February 22, 2011

Re: Comments on the Dominguez Channel and Greater Los Angeles and Long Beach Harbor Waters Toxic Pollutants Total Maximum Daily Loads, Draft

On behalf of the City of Signal Hill, Flow Science is pleased to provide comments on the “Dominguez Channel and Greater Los Angeles and Long Beach Harbor Waters Toxic Pollutants Total Maximum Daily Loads, Draft” (Draft TMDLs). Throughout this letter, the term “Draft TMDLs” is used to refer to Attachment A to Resolution No. R11-XXX, while the term “Draft Staff Report” is used to refer to the Staff Report accompanying the Draft TMDLs.

Figure 1. Modeled watershed loading rates (existing condition) for DDT. See Attachment A to these comments for details.

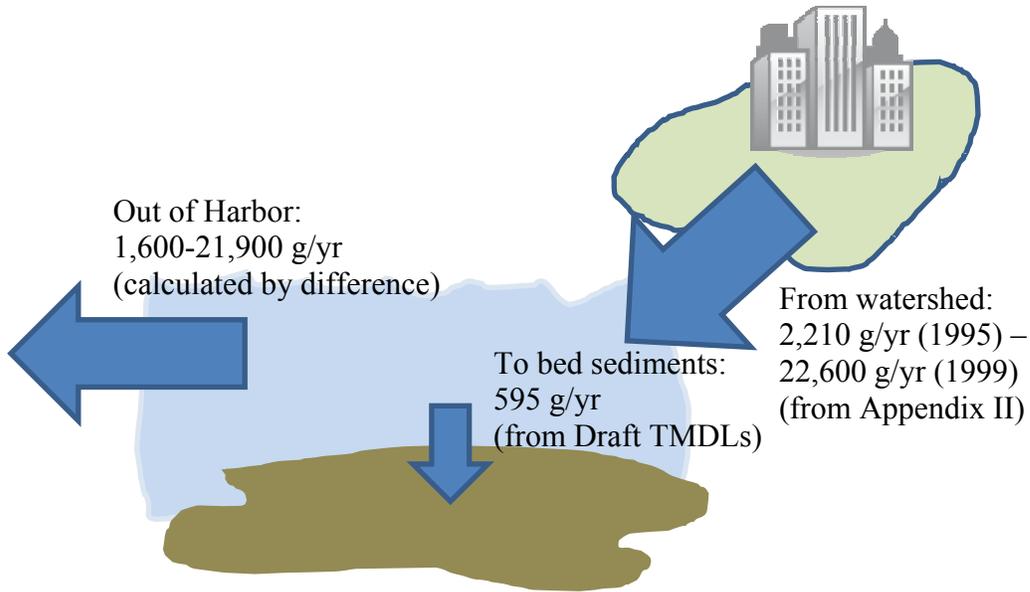
Figure 1 shows the calculated values for existing DDT loads in the Draft TMDL. As shown in this figure, a large fraction of the DDT loading to the watershed (72-97%) is simulated to pass through the Harbor without depositing to the Harbor sediments.

Figure 2. Draft TMDL-allocated (allowable) watershed loading rates for DDT. See Attachment A to these comments for detail.

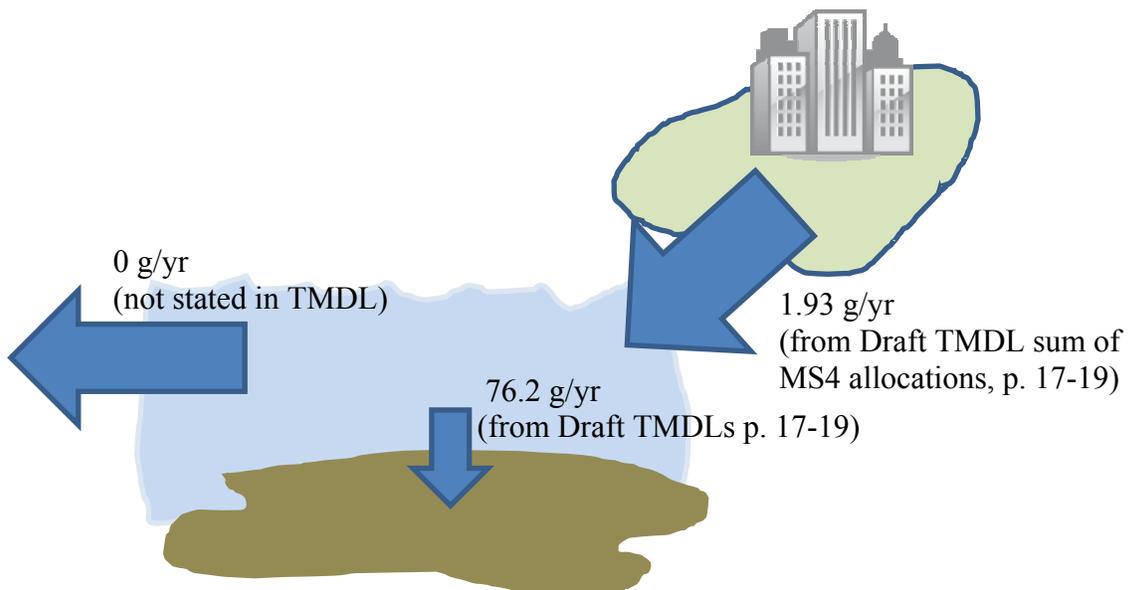
The allowable loads under the Draft TMDLs are shown in **Figure 2**. As can be seen by comparing **Figures 1** and **2** and reviewing **Table 1**, the Draft TMDLs require that loads of DDT from the watershed be reduced by 99.91% to 99.991%. Similarly large load reductions are also required for other pollutants, as shown in **Table 1**.

**Figure A-1. Sediment Quality in Los Angeles and Long Beach Harbor.
Reproduced from Figure 6 of SCCWRP (2008).**

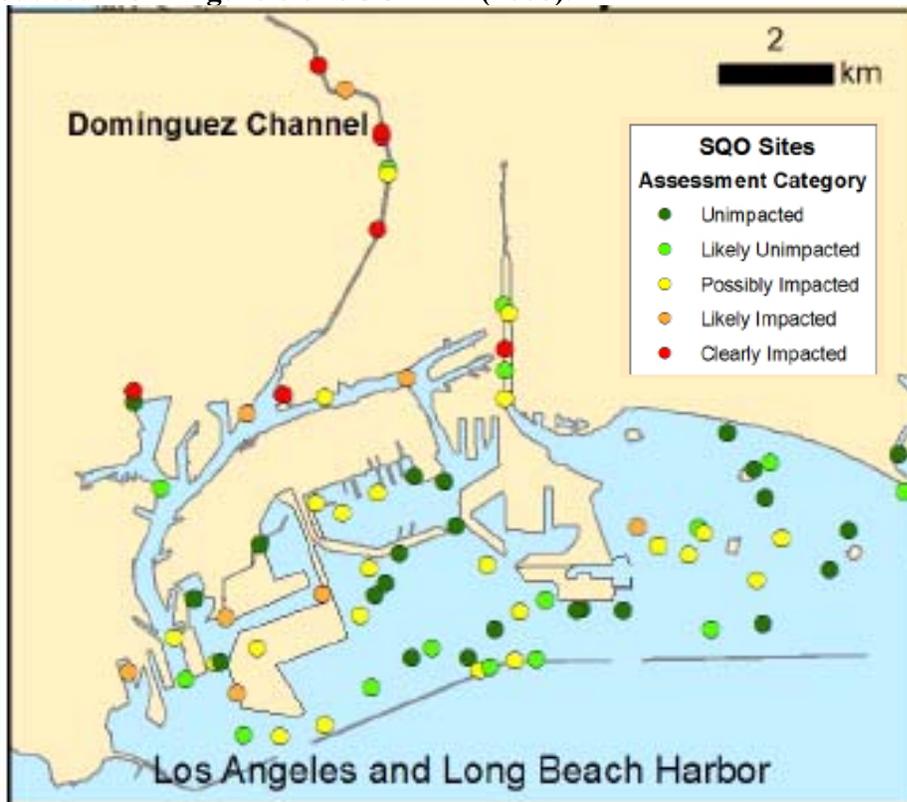
The impact of using SQGs as Draft TMDL targets can be seen by comparing assessment results under the SQO Policy with an assessment made using the Draft TMDL targets. **Figures A-1 and A-2** reproduce maps of SQO results produced by SCCWRP during SQO development (SCCWRP, 2008)³. These figures show that 35% of stations (26 of 75 stations) are classified as “unimpacted” and 17% are classified as “likely unimpacted” (dark and light green, respectively). An additional 31% are classified as “possibly impacted,” which is defined in the SQO Policy to mean that “Contamination at the site may be causing adverse impacts to aquatic life in the sediment, but the level of impact is either small or is uncertain because of disagreement among LOEs [lines of evidence].” Only 13 stations (17%) are classified as “likely impacted” (orange) or “clearly impacted” (red).

Figure A-3. Copper concentration in sediment samples in the Los Angeles and Long Beach Harbors compared to the Draft TMDL target of 34 mg/kg

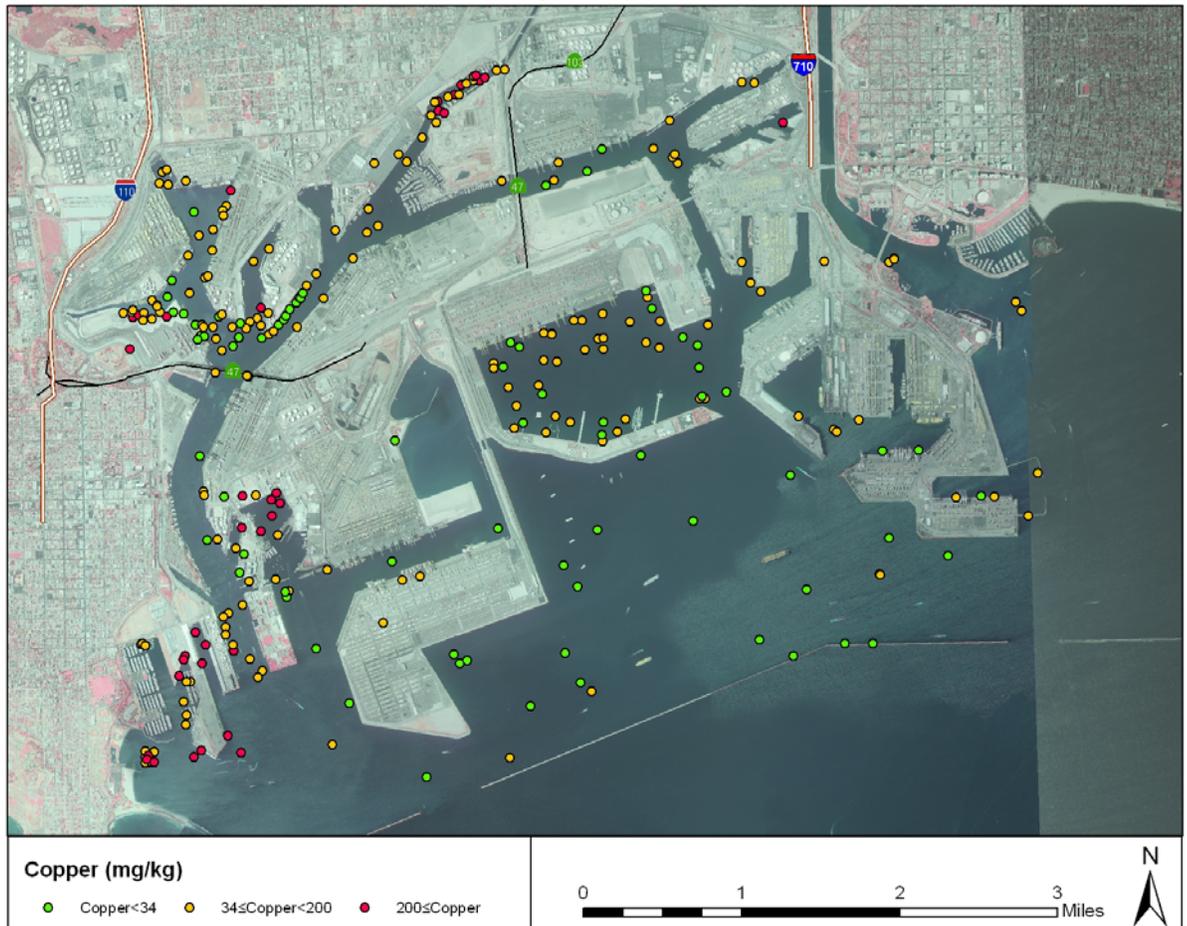
By contrast, maps produced by Flow Science for copper (**Figure A-3**) and DDT (**Figure A-4**) using data from the Los Angeles Region Contaminated Sediment Task Force Version 1.0 (www.coastal.ca.gov/sediment/sdindex.html, data collected from 1987-2009) show that virtually all of the Harbor sediment samples exceed the artificially low DDT target (316 out of 323 samples) and about 69% of the Harbor sediment samples exceed the artificially low copper target (224 out of 323 samples) of the Draft TMDLs. See **Figures A-3** and **A-4** below. Thus, the Draft TMDL methodology using SQGs indicates that radically larger areas of the Harbor complex will require remedial measures such as dredging or capping, than

Figure A-4. Total DDT concentration in sediment samples in the Los Angeles and Long Beach Harbors as compared to the Draft TMDL Target of 1.58 ug/kg

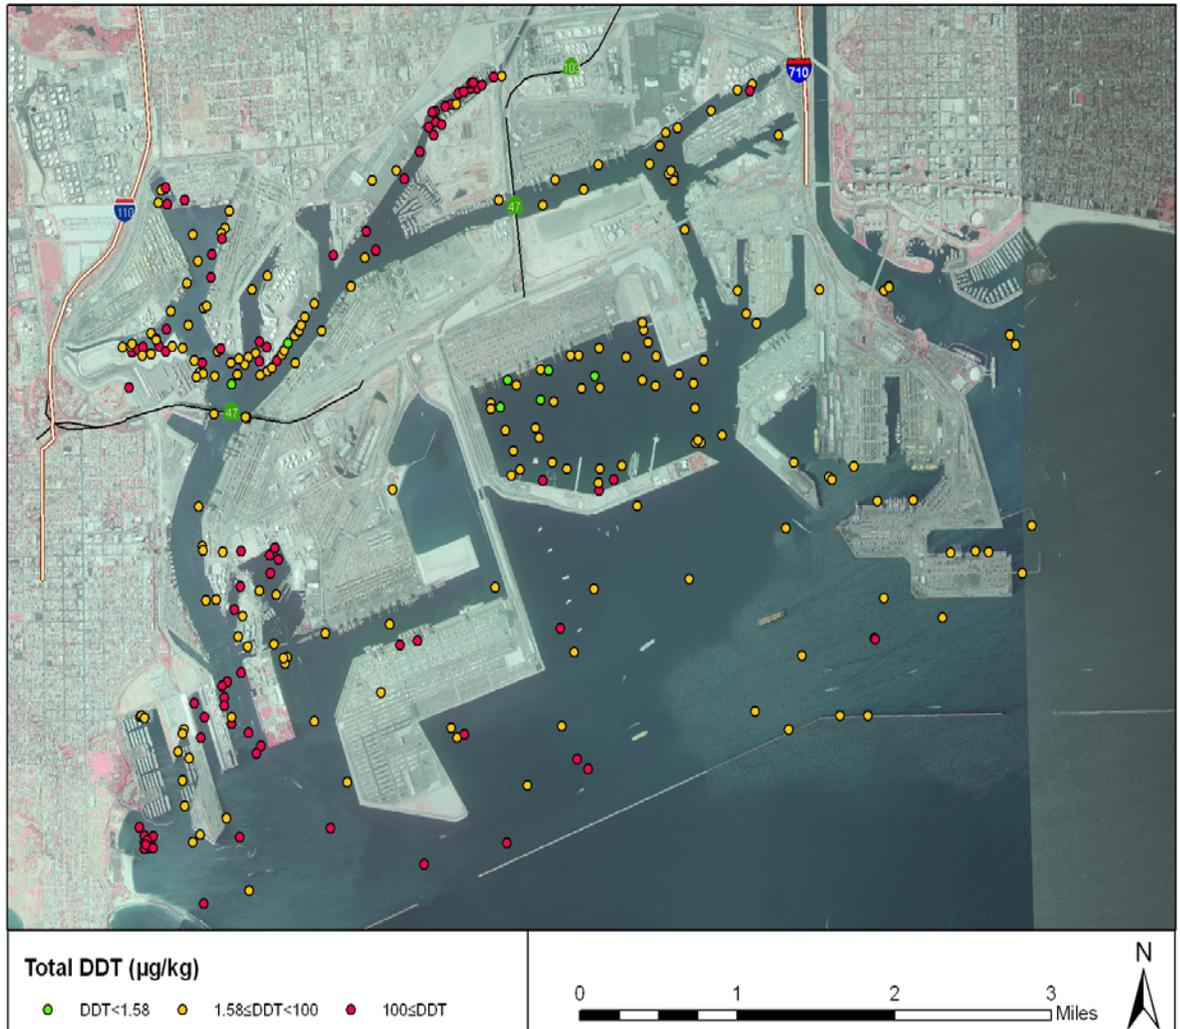
Based on maps showing contaminant concentrations in the harbor sediments—such as **Figure A-4** above—it seems that sediments in every part of the Harbor complex exceed the pollutant targets of the Draft TMDL, and thus that the entire Harbor complex must be dredged and/or capped in order to meet the requirements of the TMDL. Therefore, it seems doubtful that dredging/capping will be limited to seven areas within the Harbor complex as suggested by the Staff Report. Indeed, dredging required by the TMDL could be much more extensive than currently envisioned in TMDL documents, and would likely exceed the 35 million cubic yards listed in Table 7-3 at p. 125 of the Draft Staff Report. Additionally, the Draft Staff report states in places (e.g., p. 124) that between two (2) and eight (8) ft may require dredging, but it appears (see p. 125) that the cost estimates and volume to be dredged assumed a dredge depth of two (2) to three (3) ft. The City requests further clarification regarding the depth to be dredged, and requests also details of the calculations of the volume of sediment to be dredged.

Figure A-5. Model results describing sediment loadings within the Harbor, existing condition.

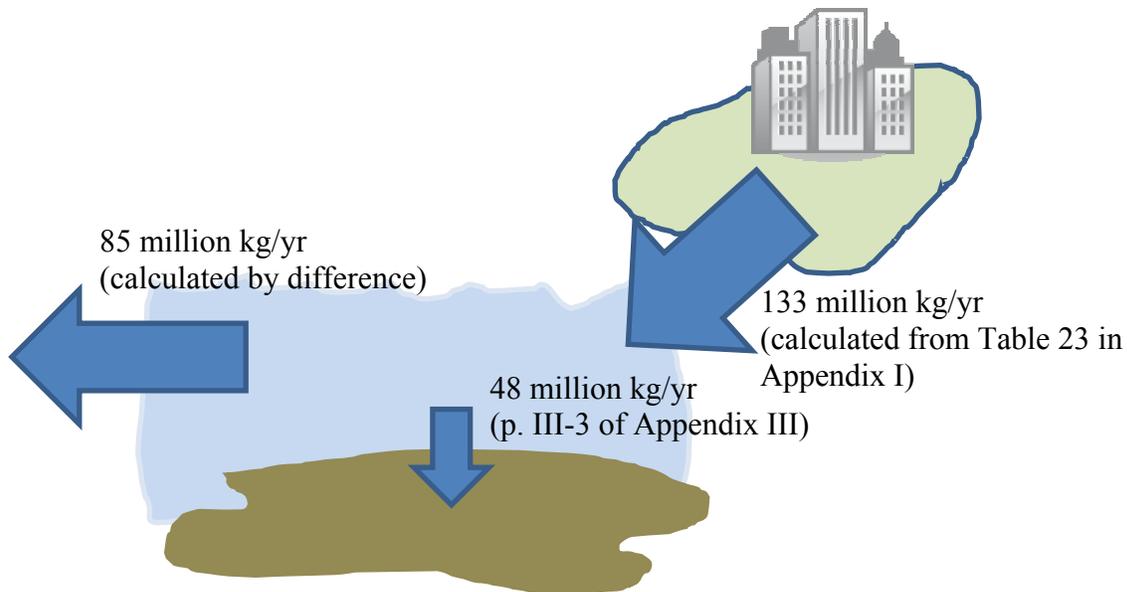
To illustrate these concerns, the model results for sediment have been compiled into **Figure A-5** below. As noted in **Figure A-5**, LSPC model results indicate that about 133 million kg of sediment enter the Harbor waters from the tributary watersheds each year. The annual average sediment deposition rate is 48 million kg/yr. Thus, about 85 million kg/yr of sediment that enters the Harbor from the watersheds exits the Harbor without depositing to the Harbor bed sediments.

However, the loading capacity describing the allowable flux of DDT to Harbor sediments was established by multiplying the flux of sediment to the Harbor bed (about 48 million kg/yr, see **Figure A-5**) by the TMDL sediment target (e.g., for DDT, 1.58 ppb, see **Table A-1**). This calculation yields a result of 76.2 g/yr, as shown in **Figure A-7**. The Draft TMDLs further assign a waste load allocation (WLA) to MS4 discharges, which appear to represent all discharges from the watershed (i.e., excluding TITP). As shown in **Figure A-7**, the waste load allocation for MS4 discharges from the watersheds is 1.93 g/yr. Thus, it appears that the Draft TMDLs are requiring the load of DDT from the watersheds to be reduced from about 2,210-22,600 g/yr (existing loads) to 1.93 g/yr (sum of MS4

Figure A-6. Modeled watershed loading rates for DDT, existing condition.

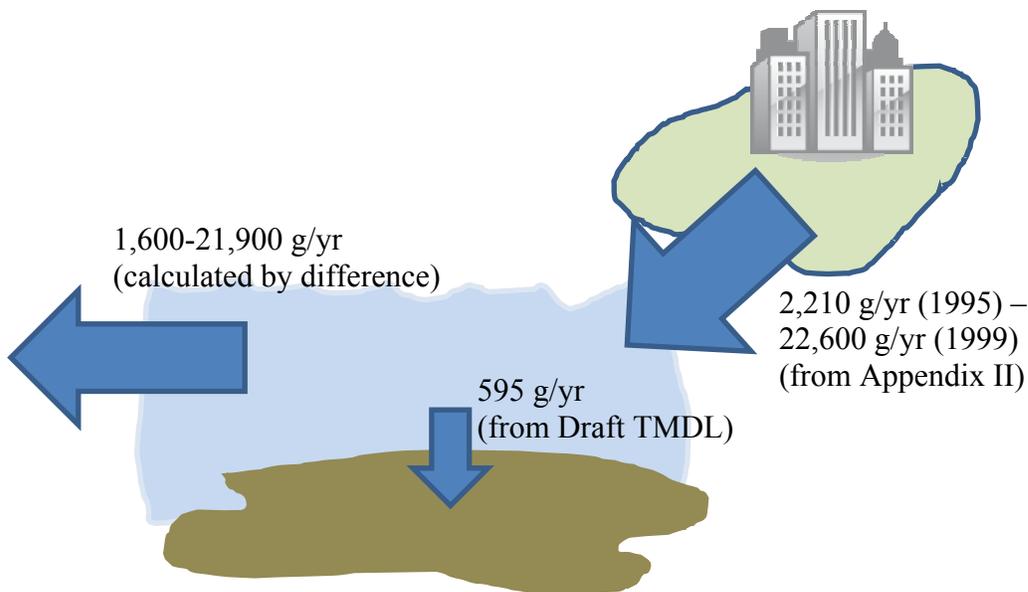
Similar mass loading rates can be calculated from the pollutant loads provided in the modeling appendices and in the Draft TMDL Staff Report. For example, **Figure A-6** below shows the loading rates for DDT, and indicates that only 2.6%-27% of the DDT that enters the Harbor from the watersheds deposits to the Harbor sediments.

Figure A-8. Left two panels: Modeled and observed DDT and PCBs concentrations for the Forest Subwatershed. Right two panels: Modeled and Observed DDT and PCBs concentrations for the Pier A subwatershed.

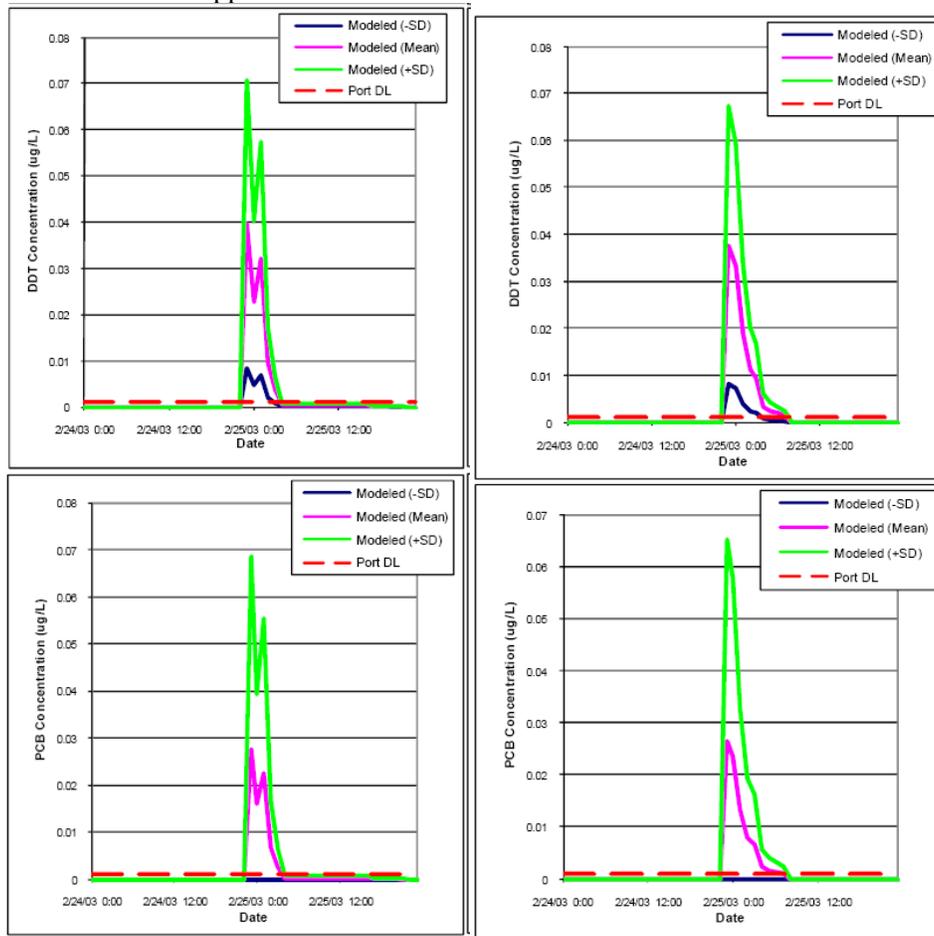
Of most concern, however, is that this method of estimating pollutant loads from the watersheds does not appear to yield realistic results. As shown in **Figure A-8** below for DDT and PCBs (reproduced from Figures 24 and 25 of Appendix II to

Figure A-9. Modeled and Observed TSS for the Pier A Subwatershed. Reproduced from Figure 8 of Appendix II of the Draft Staff Report.

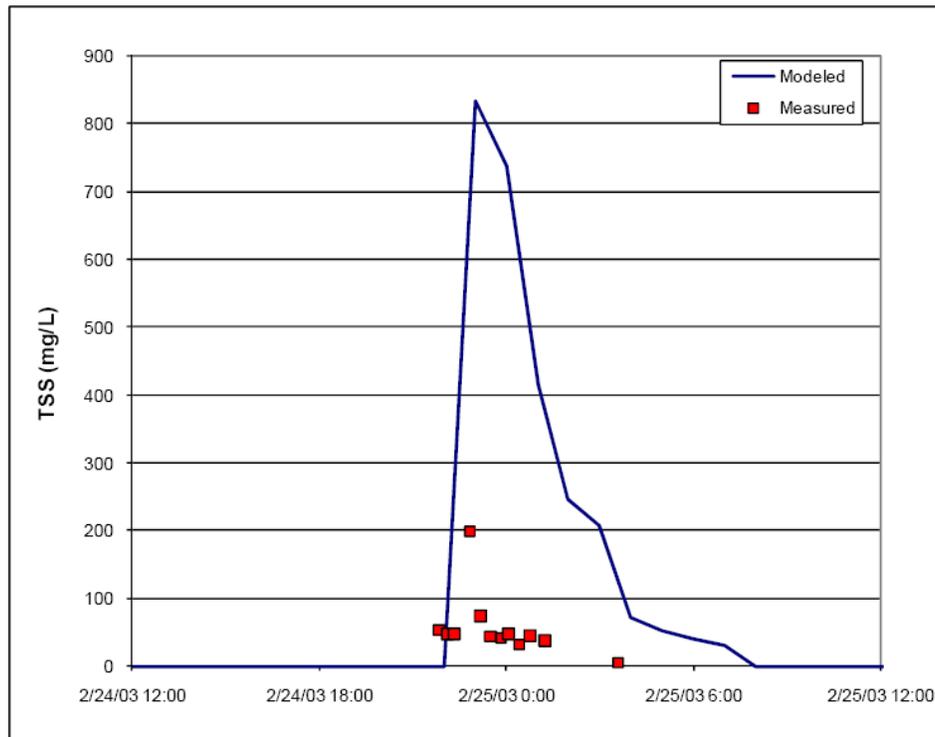
The results indicate that model predictions only marginally resemble the observations for the single storm event used in the analysis (e.g., see Appendix II, Figures 5-9, pg. 16-21). Model performance during the calibration and validation phases was largely assessed qualitatively, using visual comparisons of the model predictions and observations. **Figure A-9** provides an example plot, reproduced from Appendix II of the Draft Staff Report, showing that the model appears to overestimate TSS concentrations in runoff from the Pier A subwatershed quite dramatically.

Figure 7-26. Reach 2 Event-by-Event *E. coli* Mass Balance

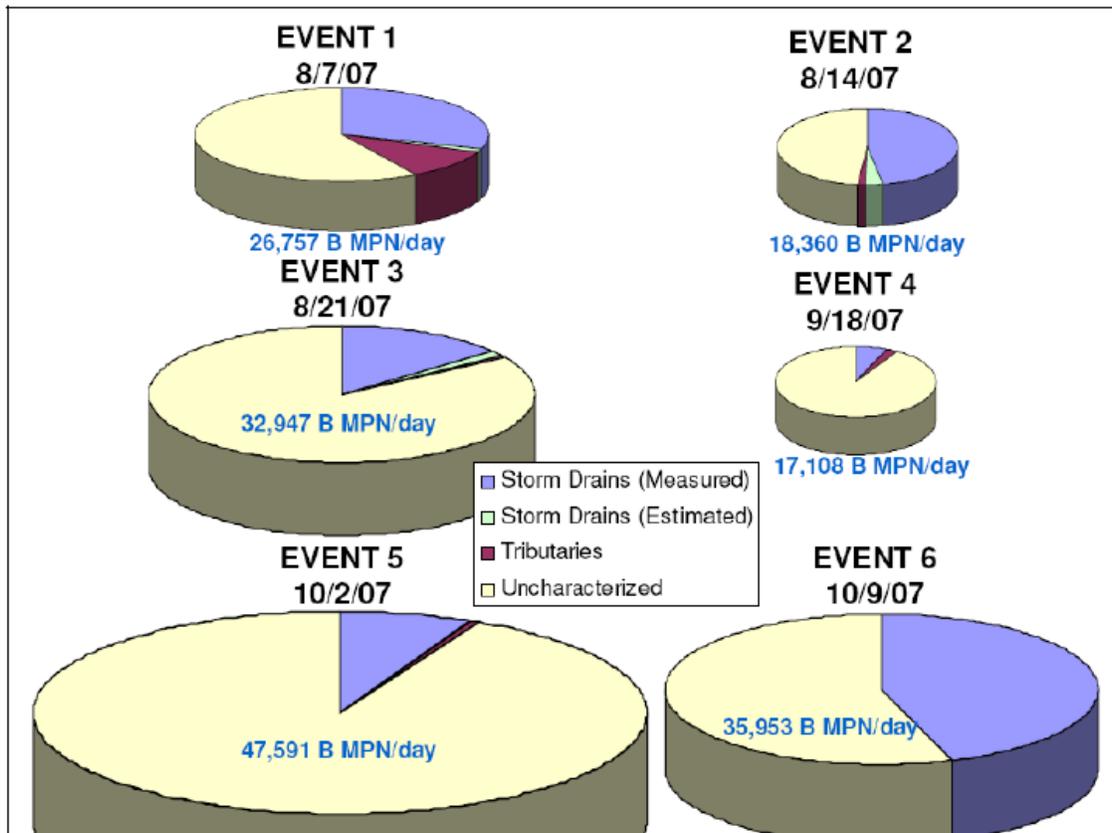
We are now fortunate to have detailed data on *E. coli* and on a human-specific bacteria (bacteroidales) from six dry weather sampling events in the Los Angeles River, which were collected as part of the CREST sampling effort.⁶ As shown in **Figure 7-26** of the CREST study (at p. 7-59, and reproduced below), only about 10-50% of the bacteria measured in Reach 2 of the Los Angeles River during six dry weather sampling events originated from storm drains and tributaries. This indicates that elimination of inflows, or elimination of bacteria in inflows, to this reach would not eliminate the exceedances of the water quality objectives for *E. coli*.

Figure 6-3. Measured *E. coli* Concentrations along the LA River

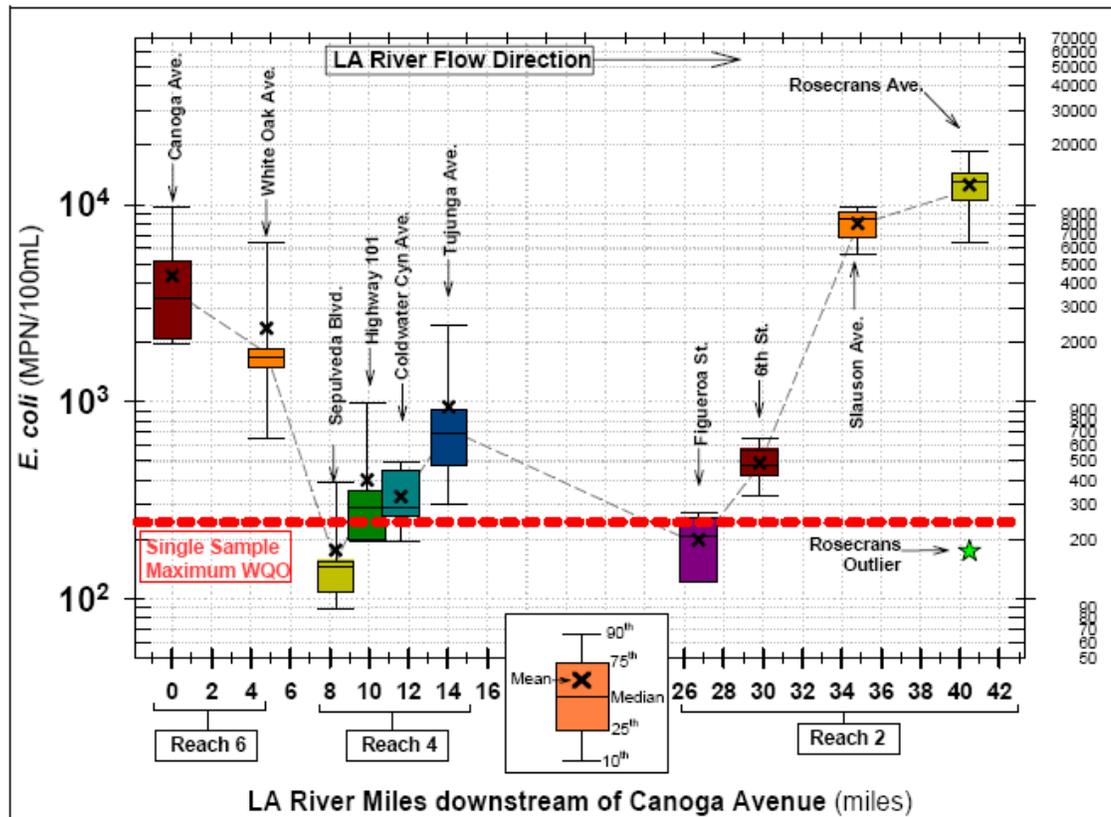
Additional information is provided by reviewing Figures 6-3 and 6-12 of the CREST report (at p. 6-11 and 6-25, respectively, and reproduced below), which show measured concentrations of *E. coli* and human bacteroidales from six dry weather sampling events along the length of the river. As shown in Figure 6-3, concentrations of *E. coli* fall to levels mostly below water quality objectives for *E. coli* downstream of sewage treatment plants. Highly purified wastewater enters the Los Angeles River between river miles 5 and 8, and between river miles 14 and 26. However, downstream of those locations, *E. coli* concentrations rise again. Note in particular the rise in *E. coli* concentrations between 6th St. and Slauson Ave.
